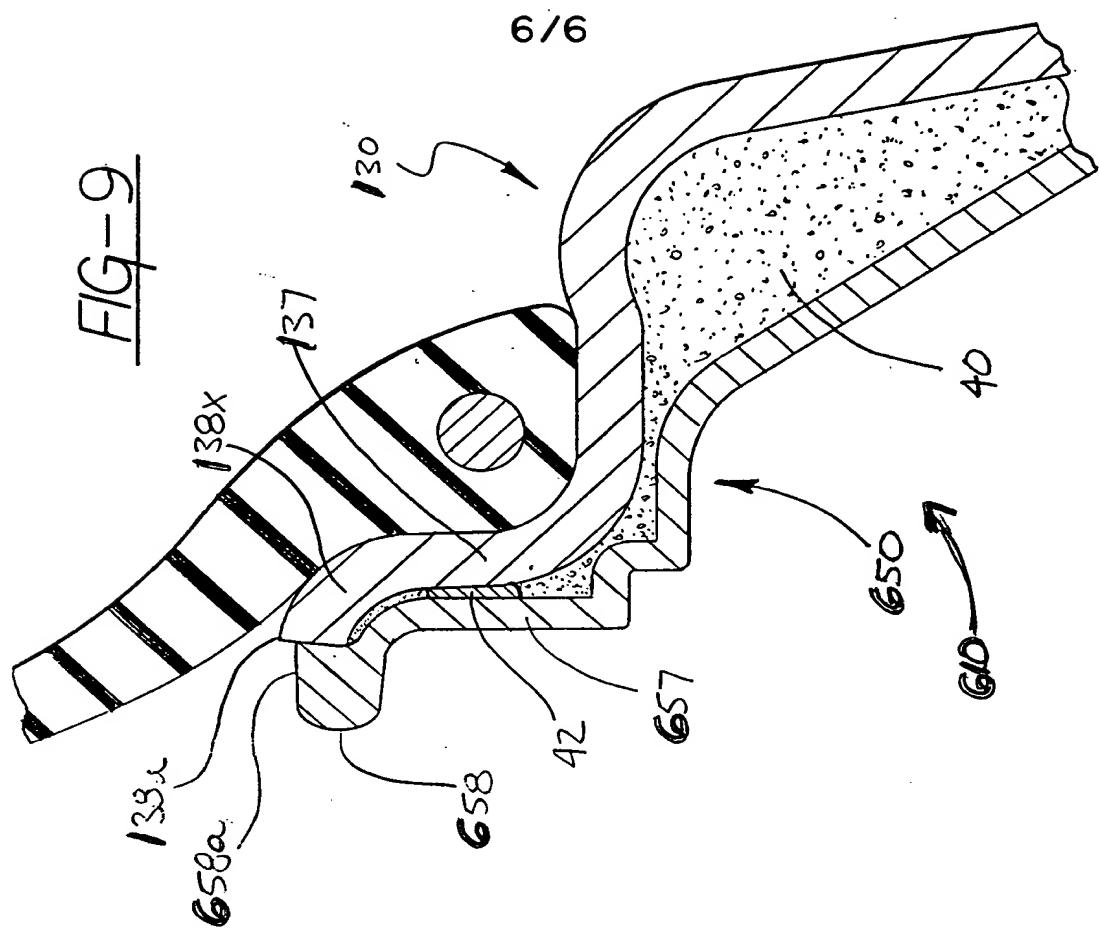
Figure 9, kindly add numeral 610, and amend numerals 30, 37, 38a, 38x, 50, 57, 58, and 58a to now read 130, 137, 138a, 138x, 650, 657, 658, and 658a, respectively.

The requested amendments are indicated in red on the attached marked-up copy of the drawings. Two marked up copies are enclosed to facilitate this request.

FIG. 10A
FIG. 10B

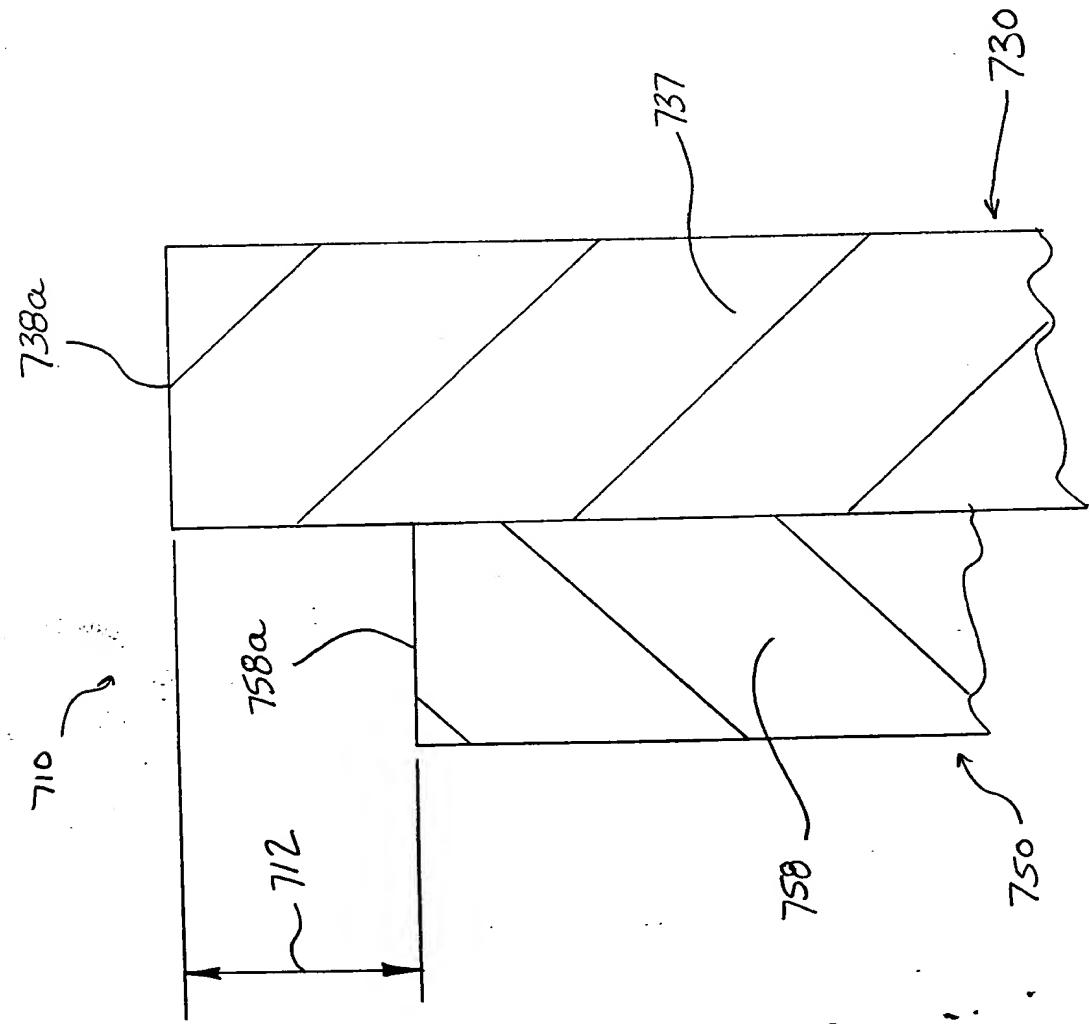
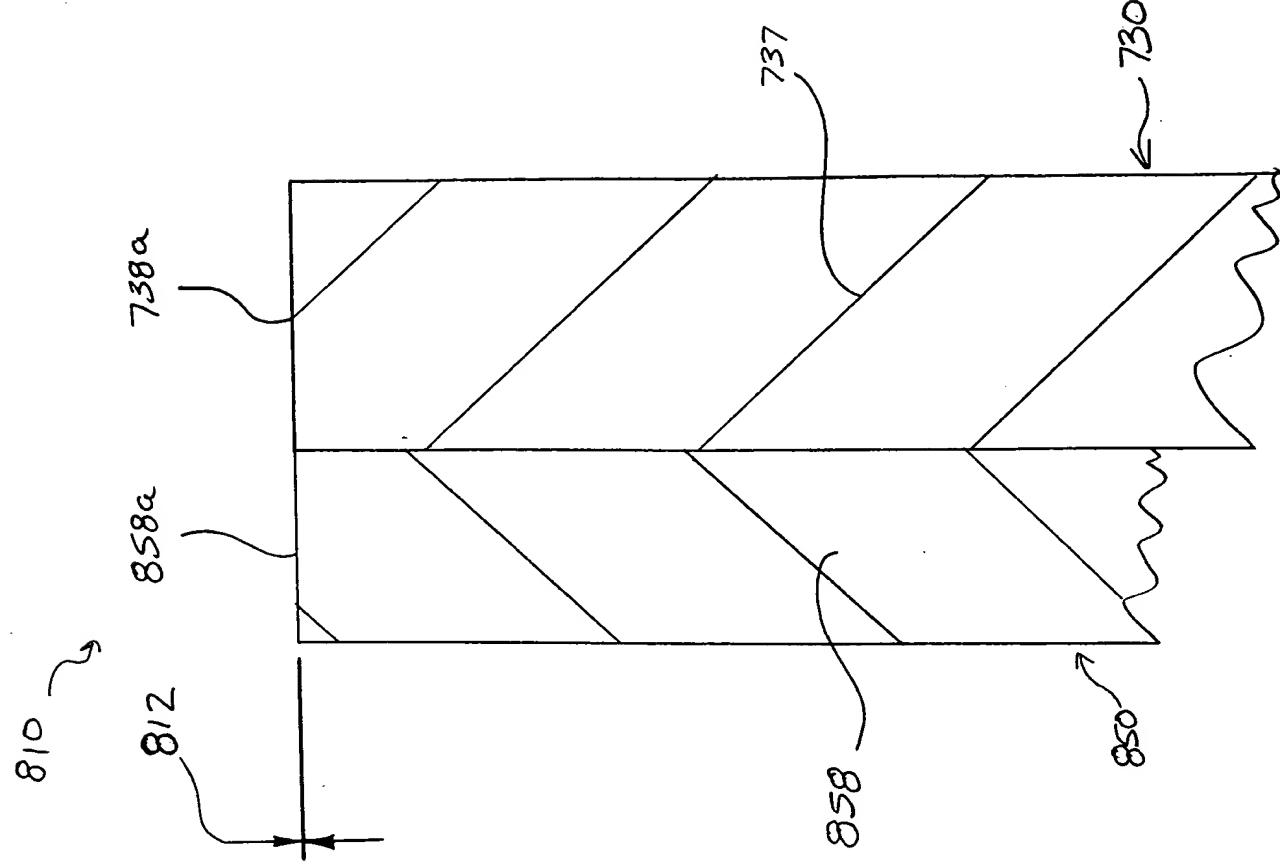
to attempt to show the margin in the existing drawing figures since all of the Figures are particularly busy with drawing lines, leader lines, and numerals, and also since the drawings are not dimensional drawings but merely exhibit features of the invention. The specification clearly discloses the margin and a person skilled in the art will clearly understand this feature from the description in the specification. Nonetheless, Applicants' attorney elects to submit herewith additional enlarged drawing Figures 10A and 10B that more clearly illustrate the margin per the Examiner's request. As described in the originally filed specification at page 19, lines 8-24, and page 20, lines 1-16, and page 22, lines 13-15, the margin of the preferred embodiment can be specified as 0 mm per side with a unilateral tolerance of -1.6 mm. Therefore, Figure 10A shows the margin at one end of the extreme of -1.6 mm, and Figure 10B shows the other end of the extreme with the margin of 0 mm.
